ADDENDUM NO. 2

MAKUU OFFSITE WATER SYSTEM PHASE 2 PRODUCTION WELL, RESERVOIR AND SUPPORTING FACILITIES

HALONA, PUNA, ISLAND OF HAWAII, HAWAII

IFB NO.: IFB-13-HHL-002

SHEET $C\!-\!6$ OF

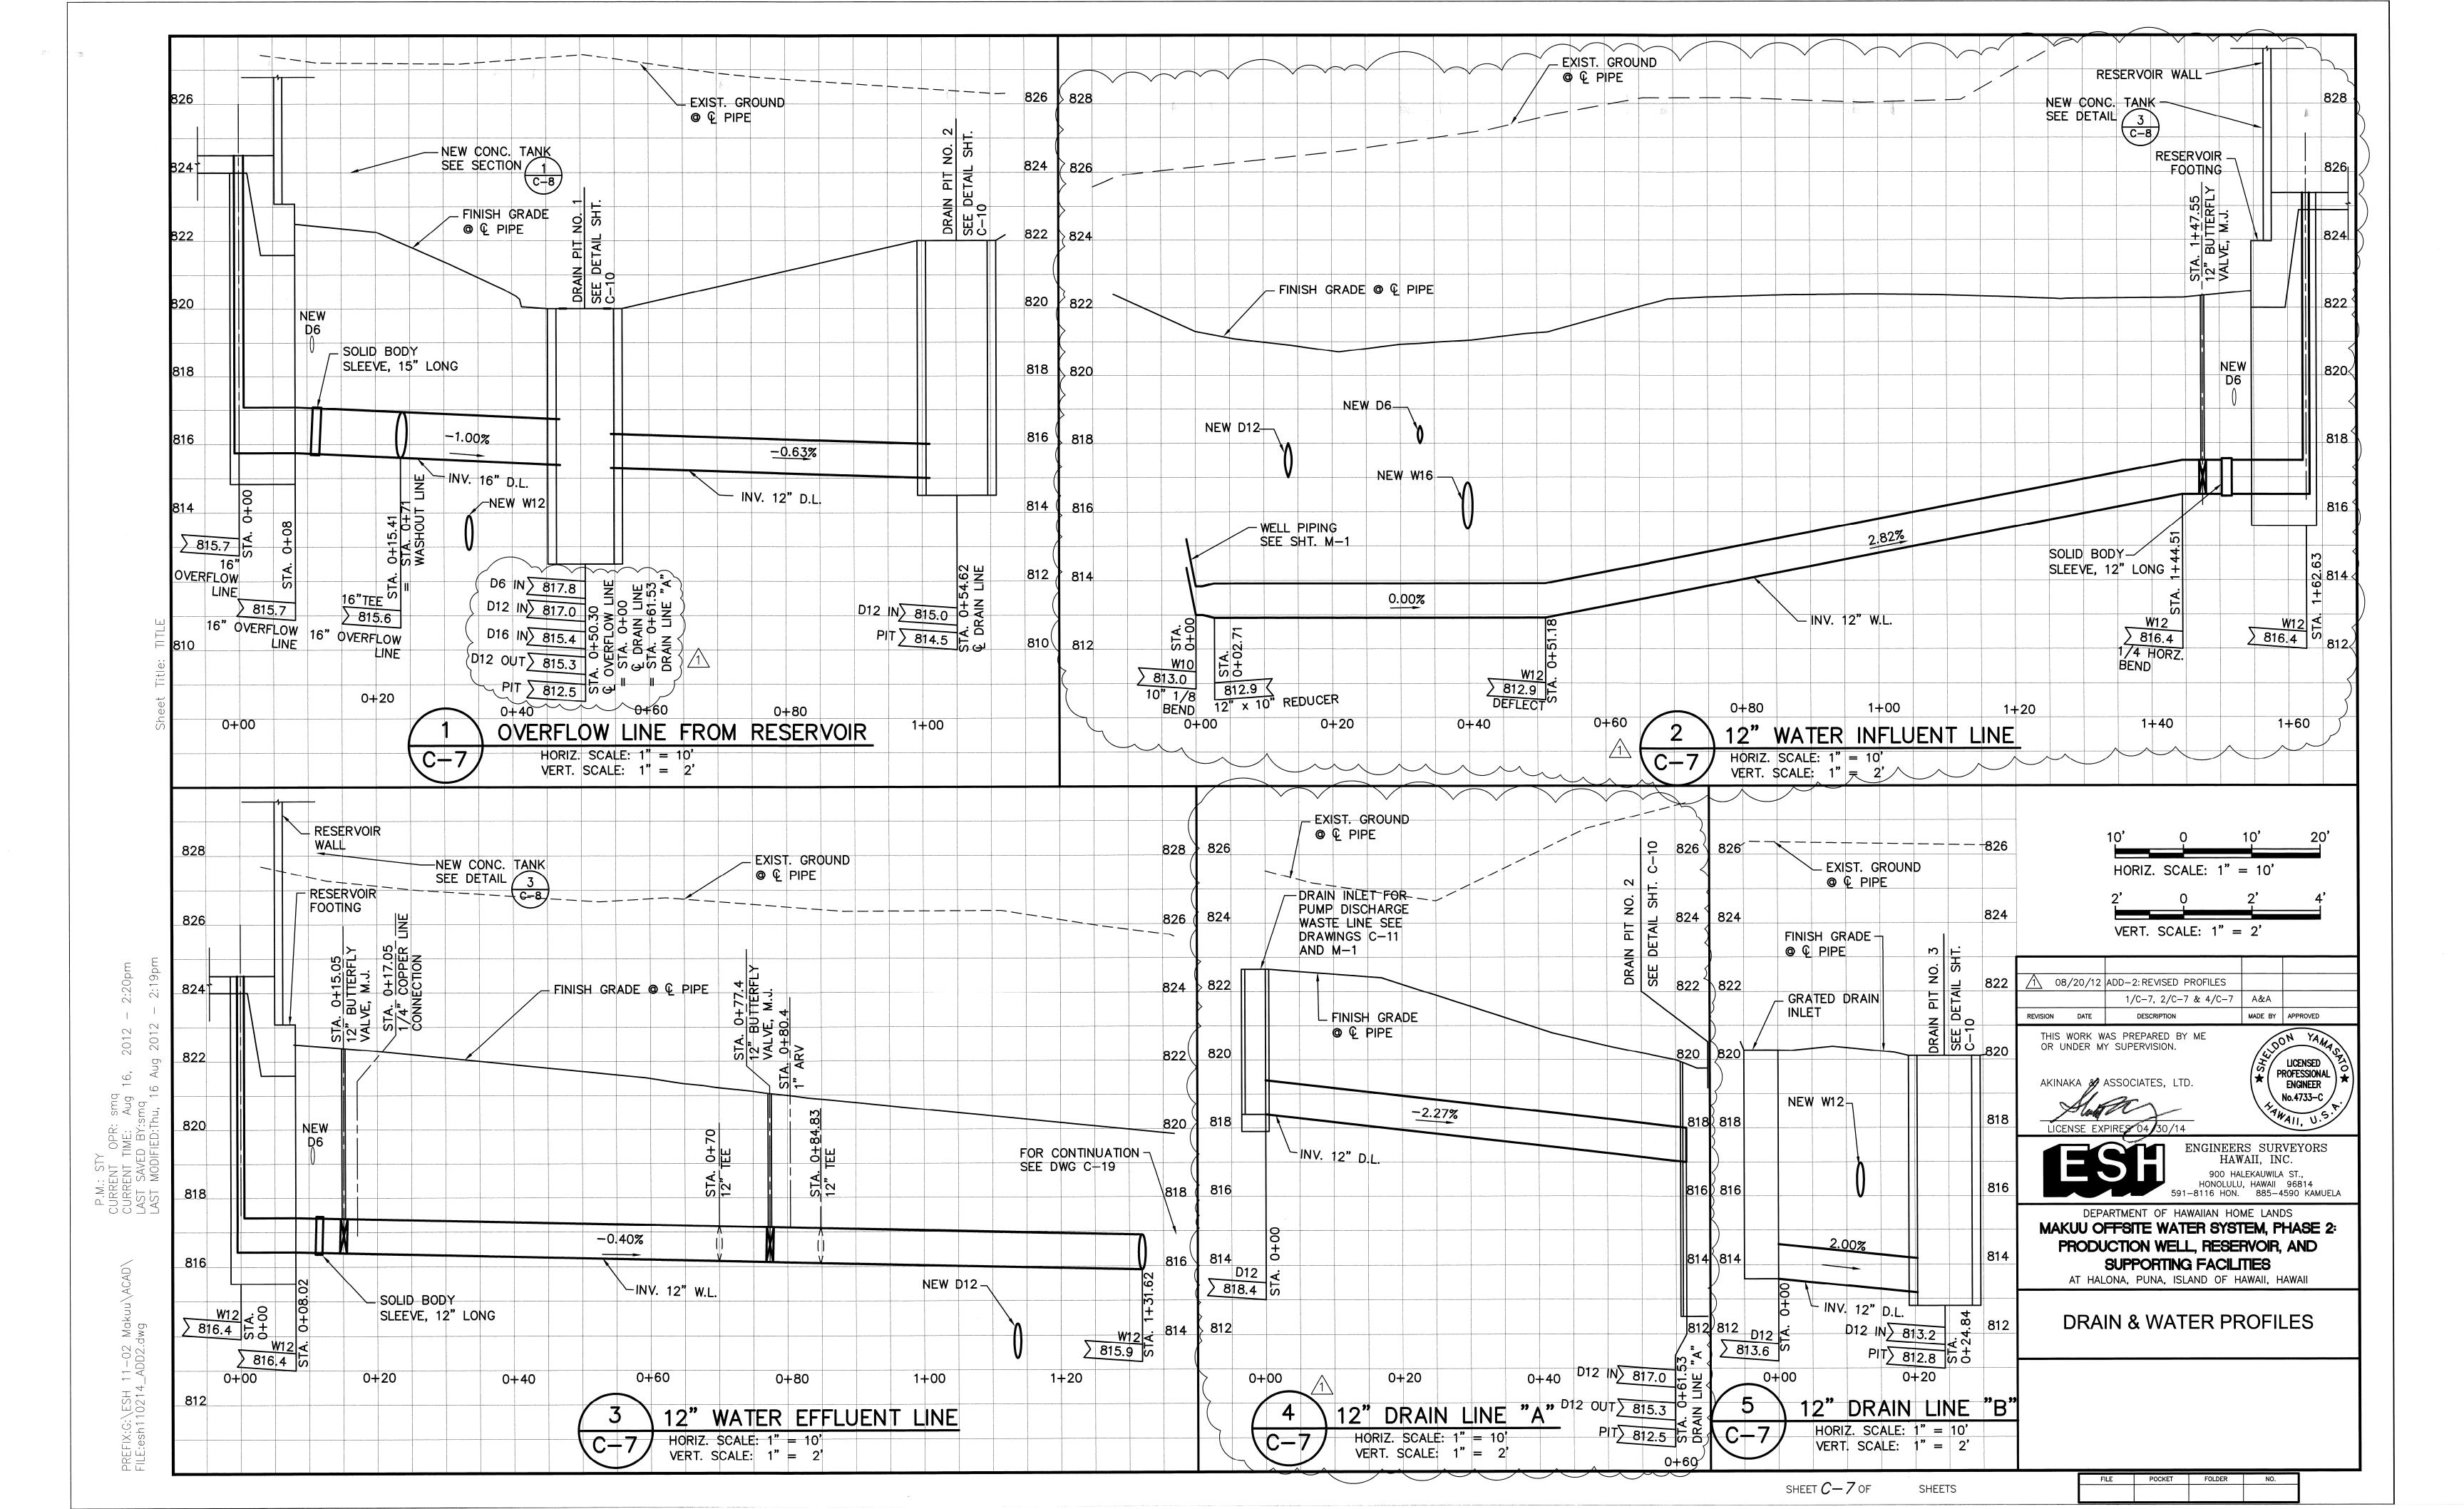
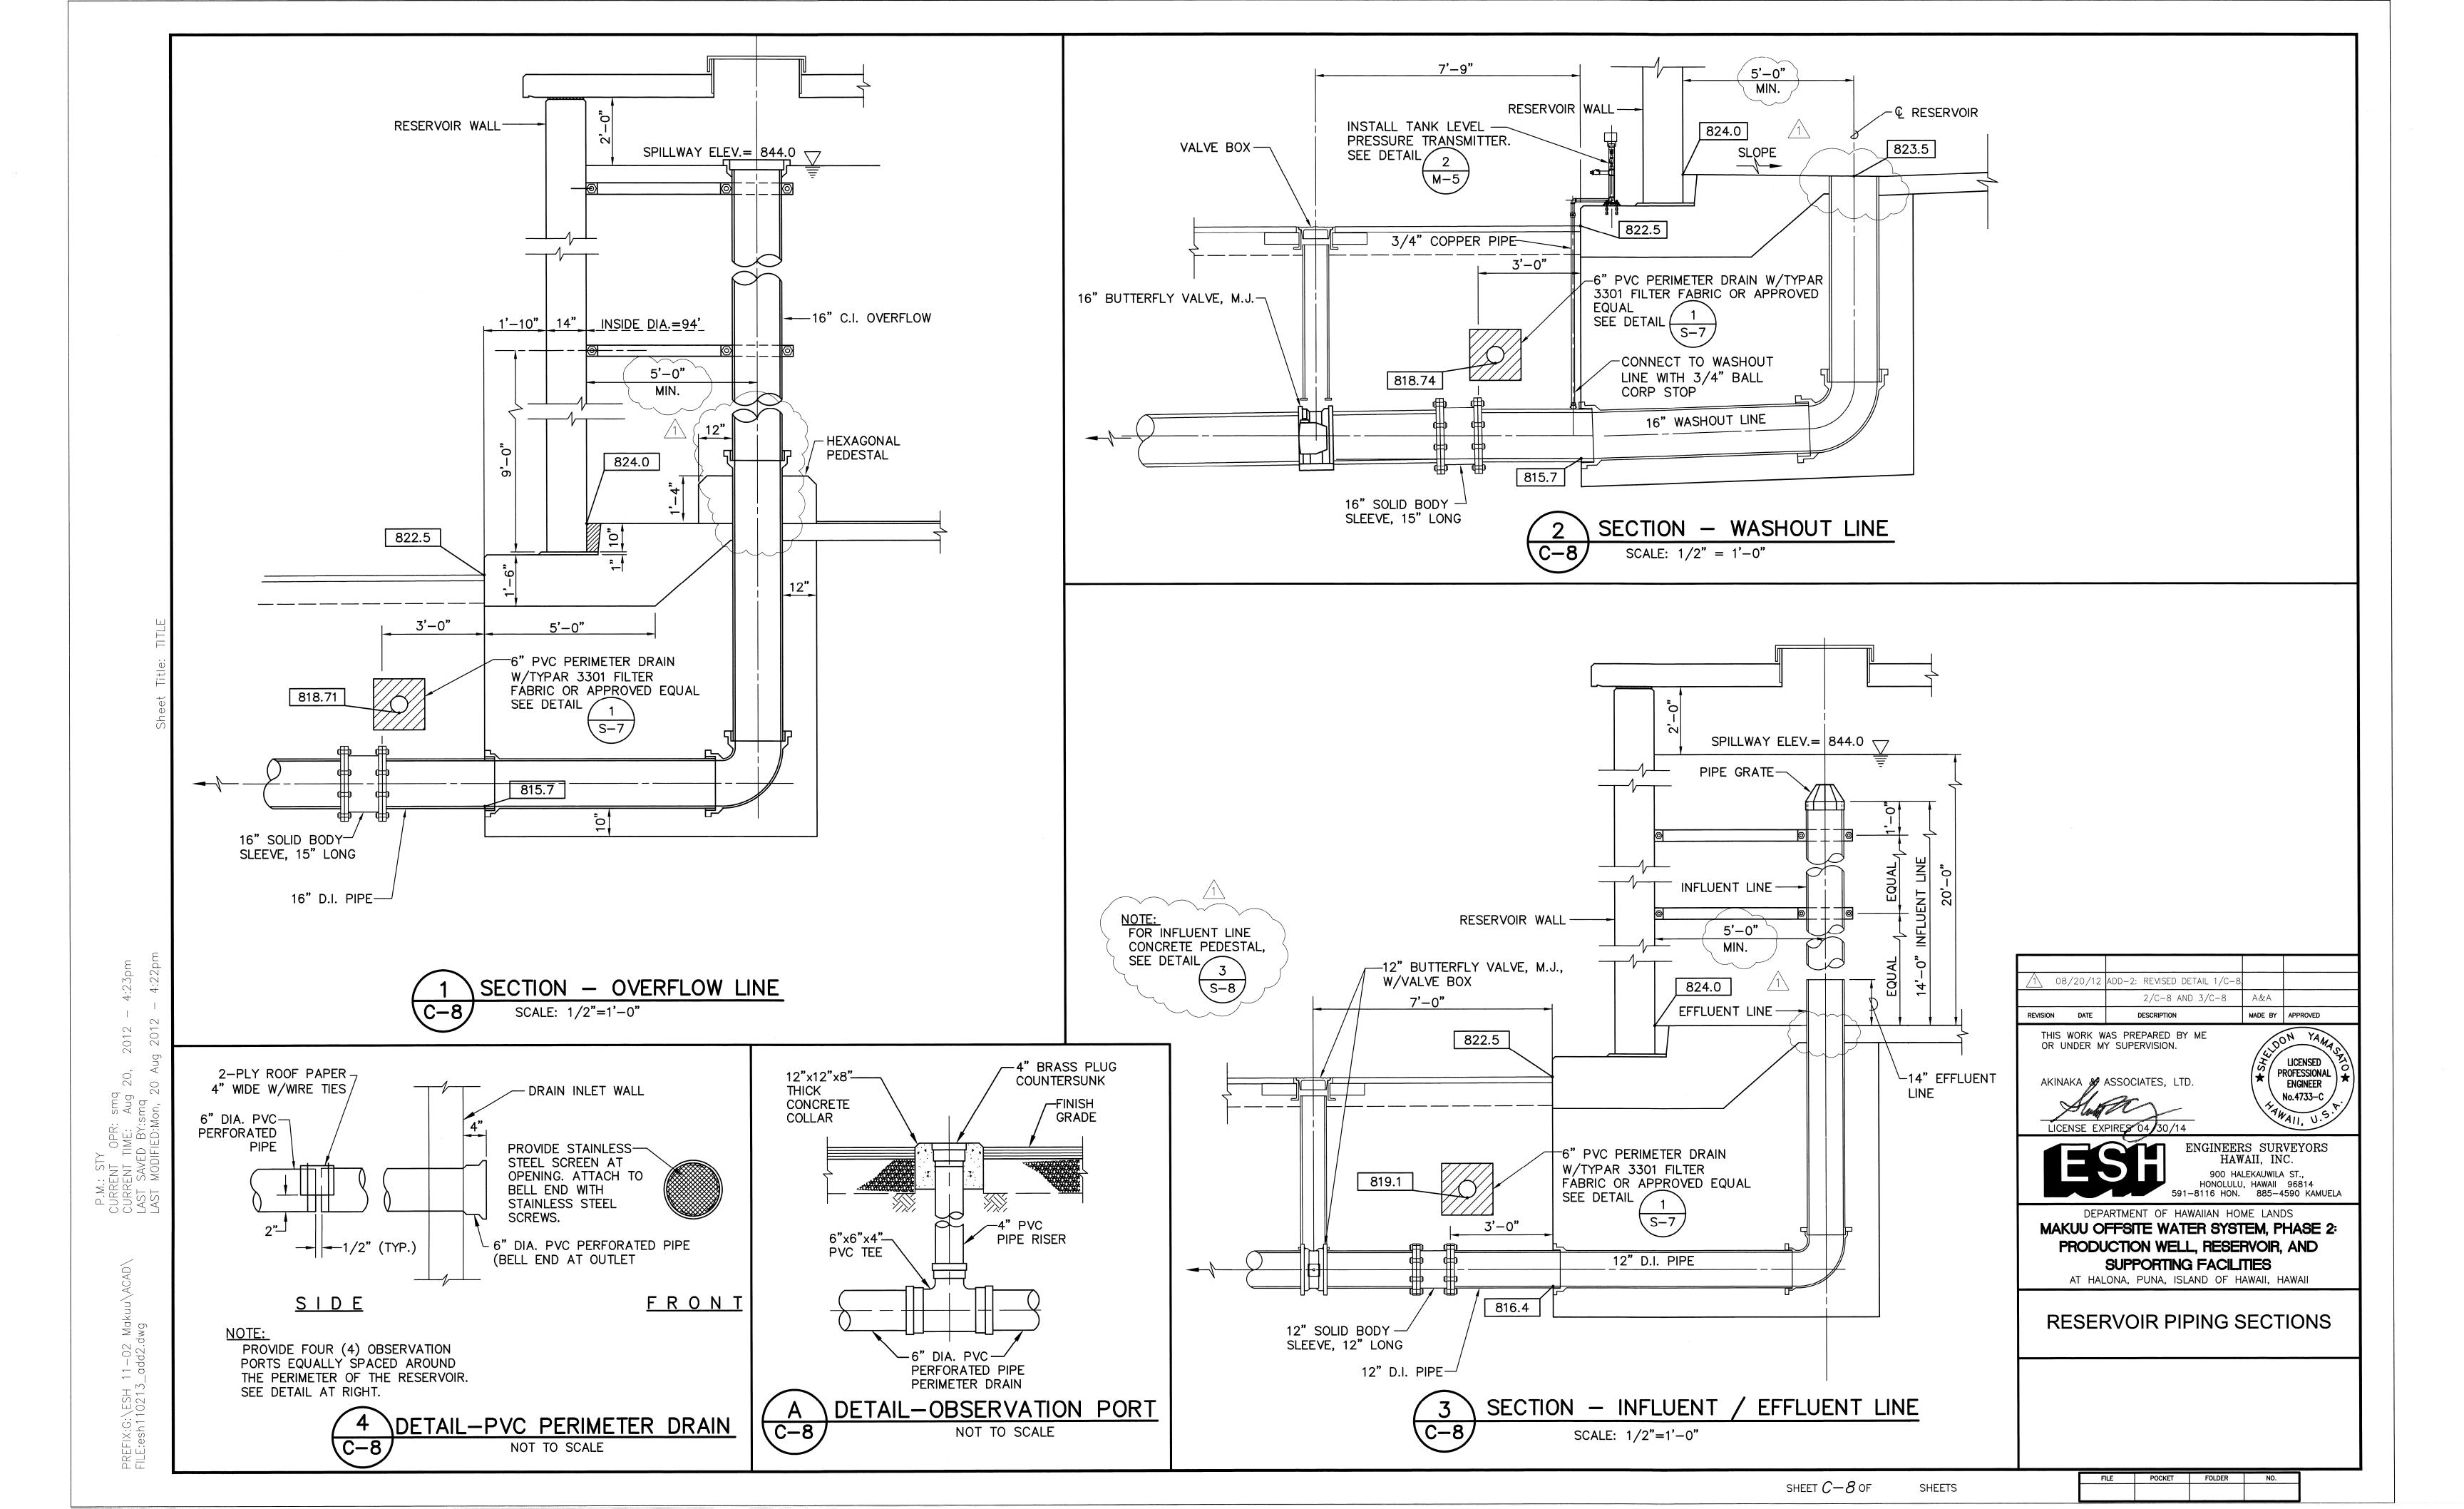
Proposal Item No. 40 of the subject project shows a proposal quantity of 3 each grated drain inlets, but we are only able to locate 1 each of the drain inlets (Note No. 35 on Sheet C-6).

Proposal item 40 has been revised in this addendum, there is only one drain inlet. Sheet C-6 has been revised in this addendum.
